# Access Compliance Report

## Public Rights-of-Way

### (Pedestrian Signals)

Intersection ID: N/A	Main Street:	Cross Street: N/A	Location: N/A
ADA ID: BECAEB9F22BE	Signal Type: One Push Button-APS	Overall Compliance: No	Severity Score: BTN 1: N/A BTN 2: N/A No BTN: N/A
Codes/Mitigation Info/Possible Solution		Field Measurements/Component Compliance

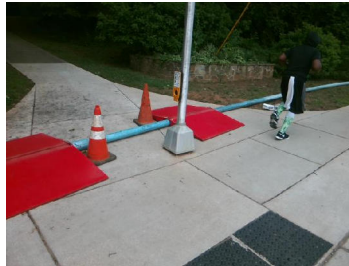
Surveyor Notes: TEXT HT 3/8

PROW/ADA: R410.6, TMUTCD 4e.08, R404.2, R404.3, R406.2, R209.1, MUTCD 4e.10

Possible Solutions: Replace Signal Push Button With APS Button on New Post. Remove & Replace Sign.
